■ 1MZ-FE ENGINE

1. Cooling System

▶ Specifications **◄**

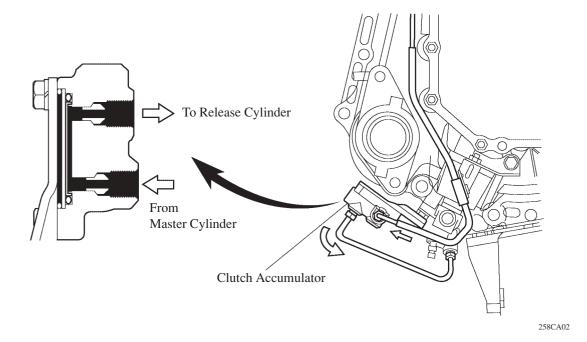
The TOYOTA genuine Super Long Life Coolant (SLLC) has been adopted. As result, the maintenance interval has been extended.

Model		New	Previous
Engine Coolant	Capacity litter (US qts, Imp. qts)	9.2 (9.7, 8.1)	9.2 (9.7, 8.1)
